SUBJECT: SEP TOPIC II-4.D, STABILITY OF SLOPES
SAN ONOFRE NUCLEAR GENERATING STATION UNIT 1

SYSTEMATIC EVALUATION PROGRAM
TOPIC II-4.D

TOPIC: II-4.D, STABILITY OF SLOPES

Figure 2 - North Plant Slope Generalized Typical Section

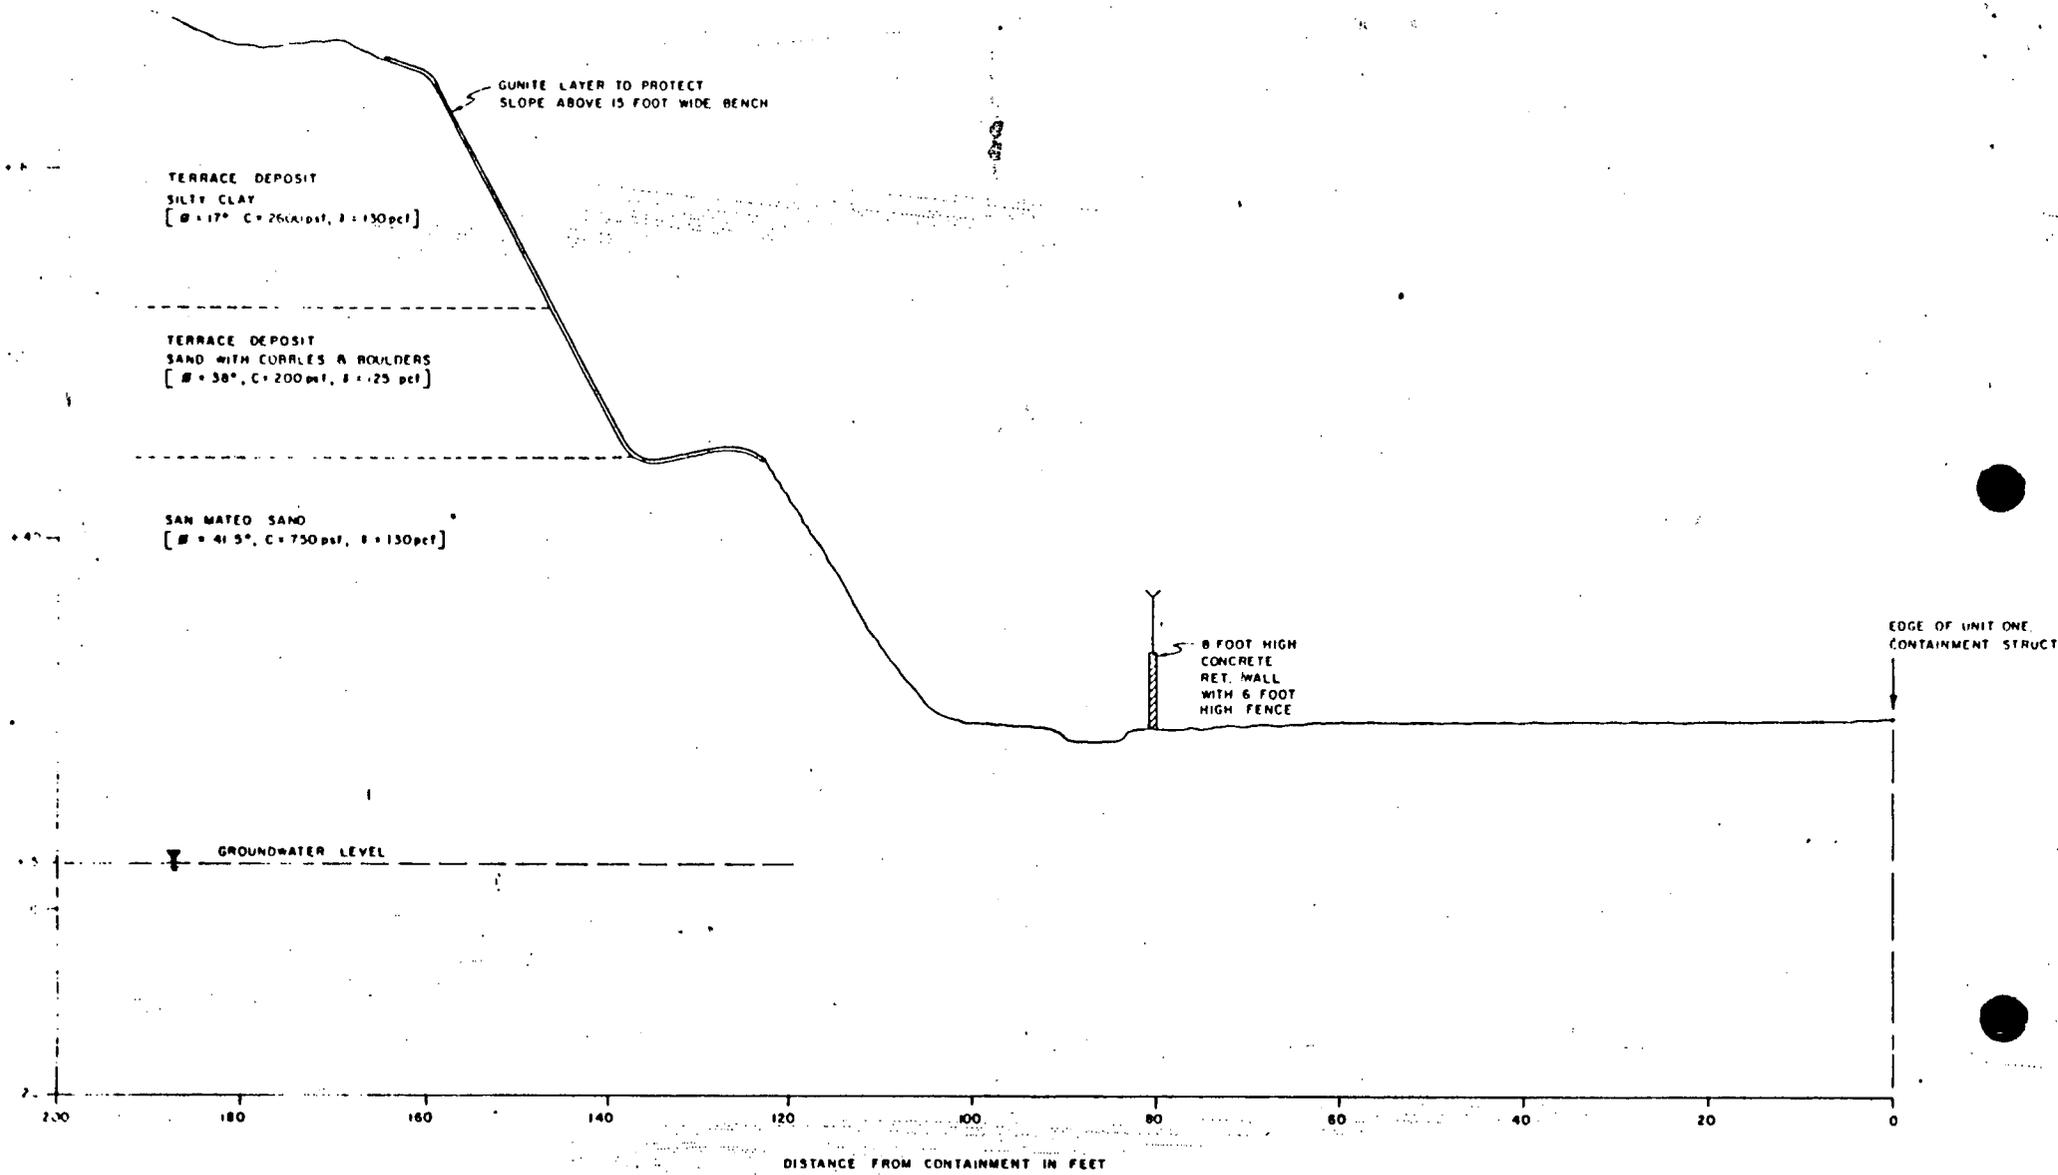
Review of available onsite and offsite topographic data indicates there are no offsite slopes whose failure could cause radiological consequences adversely affecting the public health and safety (Ref. 5). One onsite slope, the north plant site slope, was identified by the licensee and evaluated for safety in conjunction with this topic (see Fig. 1). A generalized, typical section for this slope was developed from subsurface data and is presented in Figure 2.

The staff has performed a stability analysis of this slope using conservative soil strength parameters developed from the results of the site subsurface investigation reported by the licensee as presented in Table 1. The staff used the computer program "Slope" currently commercially available for processing at McDonnell Douglas Automation Company (MCAUTO). Slope stability was assessed under both static and pseudostatic (earthquake loading) conditions.

Results of this analysis indicate the factor of safety against failure under static loading conditions is greater than 2.0. Based upon the criteria contained in Reference 6, the staff concludes that an adequate margin of safety exists under static loading conditions.

The staff evaluated the effect of potential slope failure under dynamic loading condition using the computer program "Slope" and Newmark's procedures (Ref. 7) for estimating permanent slope displacements due to seismic loadings. The results indicate that the maximum slope displacement for unsymmetrical sliding due to an SSE event of 0.67 g is estimated to be less than 4 inches. Considering the fact that the distance separating the toe of the north plant site slope from the nearest Seismic Category I structure is approximately 105 feet, and also considering the existence of a gunite blanket overlying the slope to prevent surface erosion (Ref. 8), the staff concludes that the expected slope displacement resulting from slope instability due to a 0.67 g SSE event would not adversely impact the safety of the plant.

Based on the review of available site data and on information obtained during a staff visit to the site, the staff concurs with the licensee's conclusion (Ref. 8) that the stability or movement of slopes associated with the San Onofre Nuclear Generating Station Unit 1 site does not pose a safety concern for this plant.
